PROGRAM INFORMATION BULLETIN NO. P11-44

SUBJECT: Reissue of P07-15 - Potential Safety Hazard on Permissible  
Mobile Diesel-Powered Transportation Equipment with  
Sandvik (formerly EJC Mining Equipment, Inc.) Wet Scrubber  
Systems

Figure No. 1

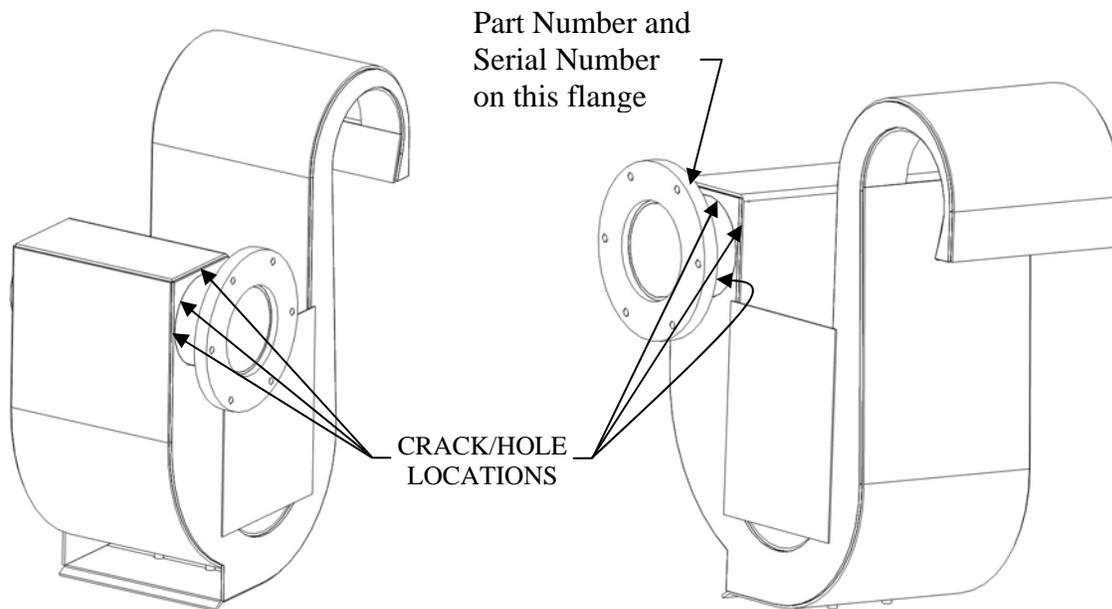
A weld bead crack failure may allow flames, sparks, or hot diesel engine exhaust gas to bypass the flame proofing, spark arresting, and engine exhaust gas cooling effects of the scrubber system and enter the mine atmosphere.

The scrubber system consists of an insert that is mounted inside an exhaust conditioner enclosure (tank partially filled with water). The crack failure developed in and near the inlet flange weld bead of the insert. Some of the weld bead cracks enlarged enough to produce a hole in the weld and surrounding material. The Sandvik wet scrubber system is used on permissible mobile diesel-powered transportation equipment to prevent propagation of flame or discharge of heated particles to the surrounding mine atmosphere and to cool the diesel engine exhaust gas at the discharge from the exhaust conditioner. The wet scrubber system is required to cool the diesel engine exhaust gas to a maximum of 170 degrees Fahrenheit per 30 C.F.R. §§ 7.98(s)(4)(i) and 36.25(c), and arrest spark and flame per 30 C.F.R. § 7.98(s)(2) and 30 C.F.R. § 36.25(b)(3).

Figure No. 1 and Figure No. 2 below can be referenced for a general view of the wet scrubber insert and the location of the cracks/holes that have been found on inserts in the field.

Wet Scrubber Insert used on the following Equipment Approval Numbers: 31-103, 31-110, 31-125, 31-135, 31-202, 31-207, 31-208, 31-211, 31-228, 31-26-3, 36C-003, 36C-005, 36C-006

located on the inlet flange of the insert as shown in Figure No. 1 and Figure No. 2 above.

All permissible mobile diesel-powered transportation equipment with a Sandvik wet scrubber system must be inspected for weld failure in the wet scrubber insert. The insert inspection should be conducted during the next scheduled weekly maintenance examination. Inserts that are found defective must be replaced with an acceptable insert. Sandvik has issued a technical bulletin to inform their customers on the proper procedure to remove and inspect the wet scrubber insert. See Attachment to view Sandvik's technical bulletin.

**Defective inserts must not be repaired.** A defective insert must be replaced with an acceptable insert. A repaired insert may not cool the diesel engine exhaust gas or arrest spark and flame. The Sandvik technical bulletin provides contact information for Sandvik authorized distributors.

Figure No. 2

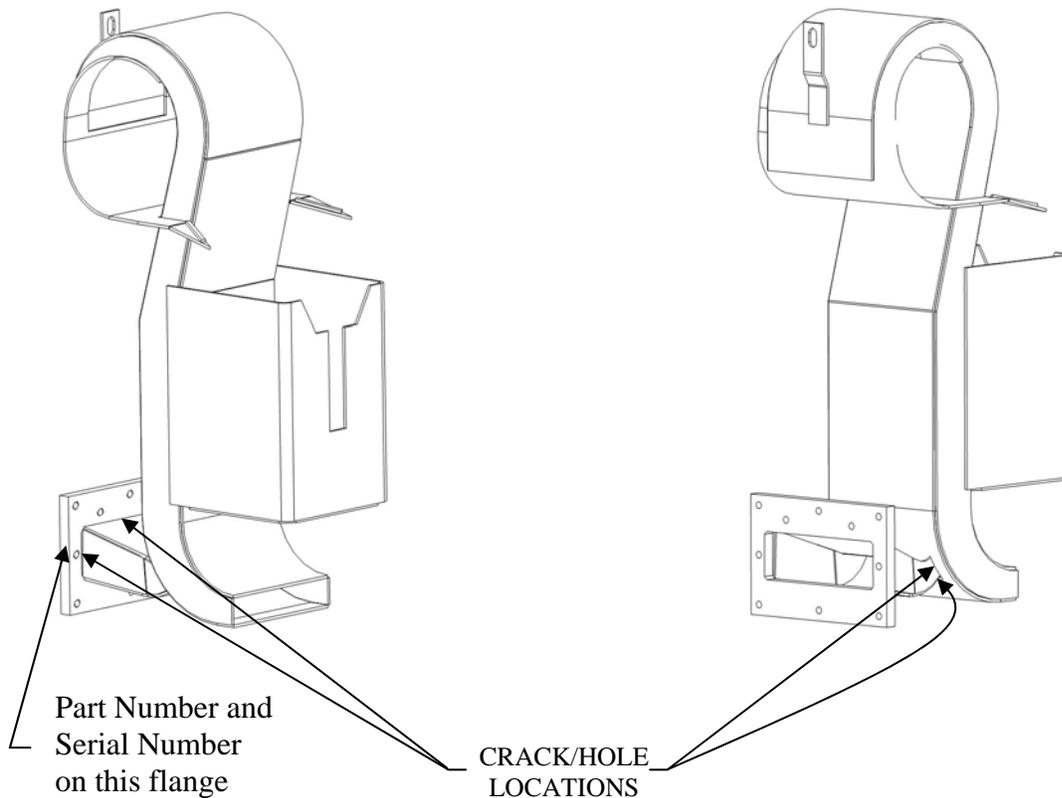
Wet Scrubber Insert used on the following Equipment Approval Numbers: 31-121, 31-117, 31-217, 31-120, 31-124, 31-126, 31-128, 31-131, 31-132, 31-137, 31-203, 31-204, 31-205, 31-206, 31-216, 36C-002, 36C-004, 36C-008
